# Sheringham Shoal and Dudgeon Offshore Wind Farm Extension Projects

## Evidence Plan

August 2022  
Document Reference: 5.2.1  
APFP Regulation: 5(2)(q)

Title: <b>Sheringham Shoal and Dudgeon Offshore Wind Farm Extension Projects          Environmental Statement          Appendix 1: Evidence Plan</b>	
PINS document no.: 5.2.1.	
Document no.: C282-RH-Z-GA-00138	
Date:	Classification
August 2022	<b>Final</b>
Prepared by:	
<b>Royal HaskoningDHV</b>	
Approved by:	Date:
<b>Sarah Chandler, Equinor</b>	August 2022

*Plate 2-1: Location (Light Blue Dots) of Evidence of Previous Native Oyster Beds within Cromer Shoal Chalk Beds (CSCB) MCZ*

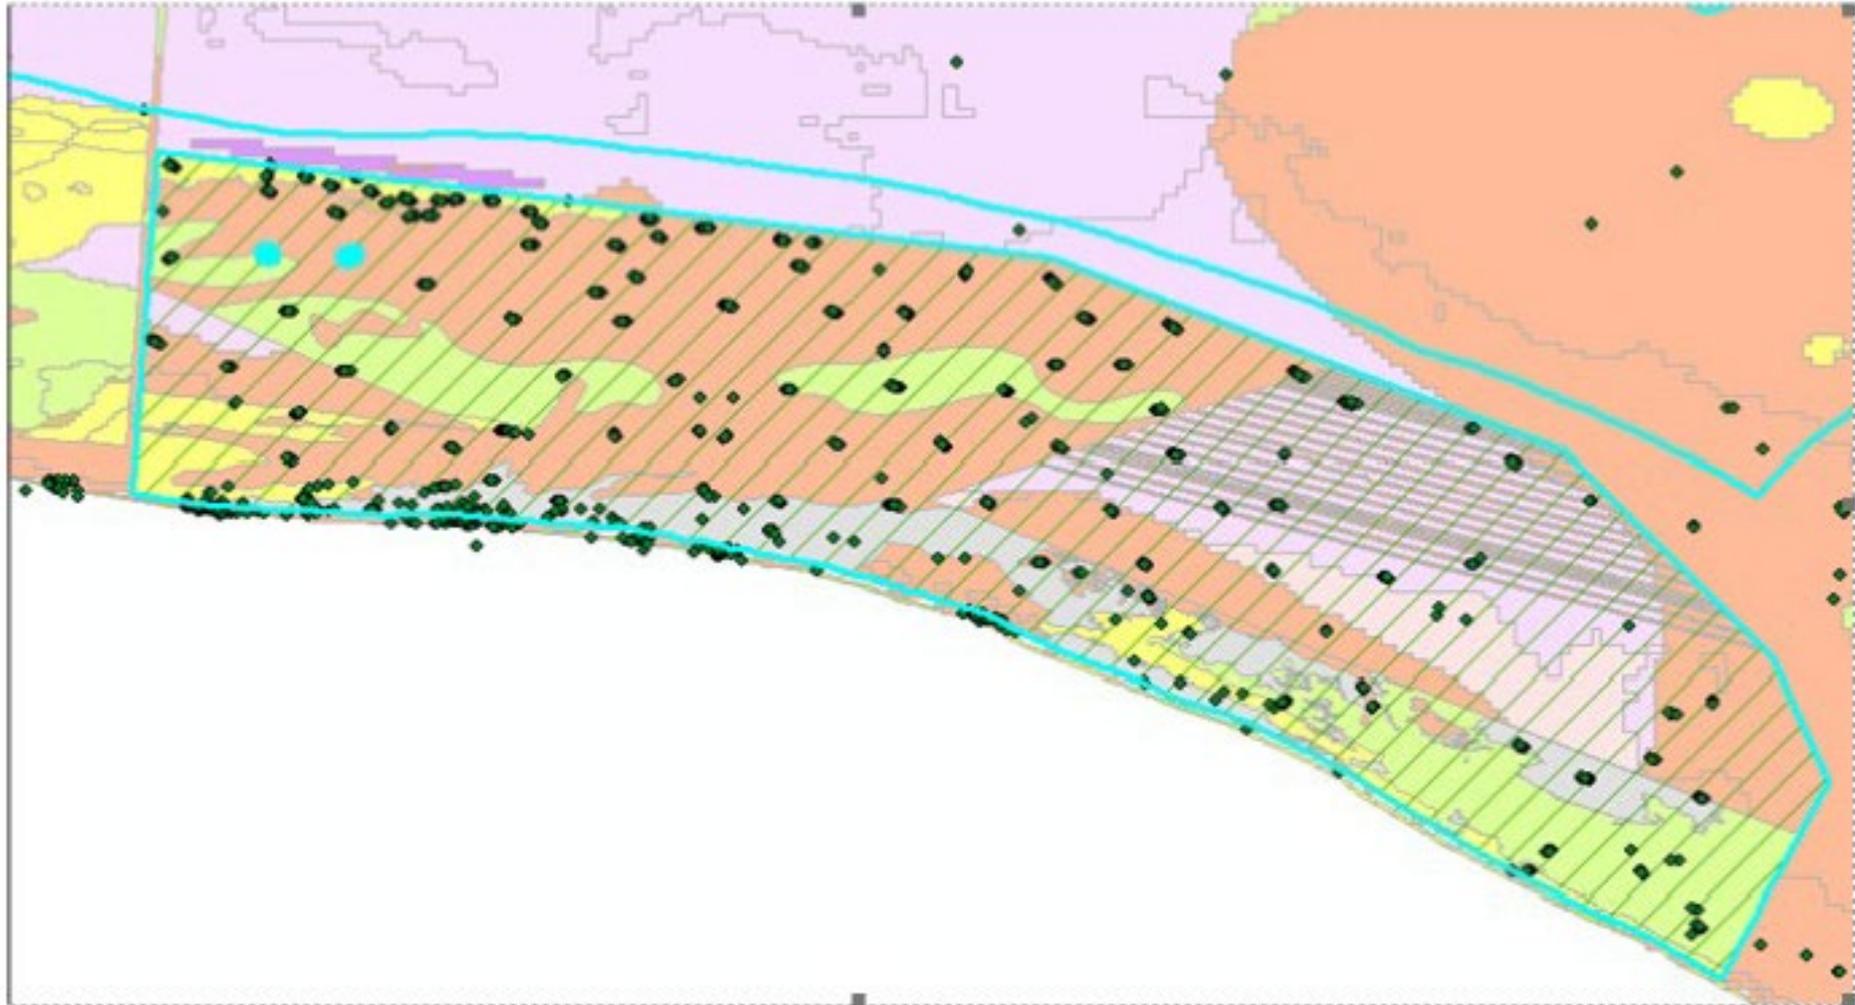
7.5	Do you agree that the area of search for determining feasibility of oyster reef planting should focus on the areas identified in <b>Plate 2-1</b> (see below) of Natural England’s advice broadening out to the	Agreed	Defer to Natural England	N/A	Not present	Not agreed	<p><u>EIFCA</u></p> <p>Concerns raised that the ‘previous oyster bed evidence’ relates to historic fisheries shell deposit grounds. In this context, we don’t agree that <b>Plate 2-1</b> should be titled “...<i>evidence of previous native oyster</i></p>

ID	Agreement	Natural England	MMO	Cefas	The Wildlife Trusts	EIFCA	Notes
	<p>wider north western portion of the MCZ and focus on subtidal sediment features avoiding potentially sensitive habitats e.g. chalk, reef etc.?</p>						<p><i>beds..”.</i></p> <p>Any potential site should be selected based on current environmental factors that are most agreeable to support the success of the MEEB.</p> <p>An effective appraisal of all environmental factors, to gain an understanding as to why native oysters have not re-established naturally should be undertaken. It would also be beneficial to find out whether native oyster beds were present in the MCZ historically – although it could be difficult to find any evidence for this. It should not be assumed that fishing is the only cause of decline in oyster stocks and distribution, and all relevant environmental factors must be considered.</p> <p>As this is an MCZ social and economic factors should be considered when evaluating any intervention, even those for conservation benefits such as MEEB.</p>
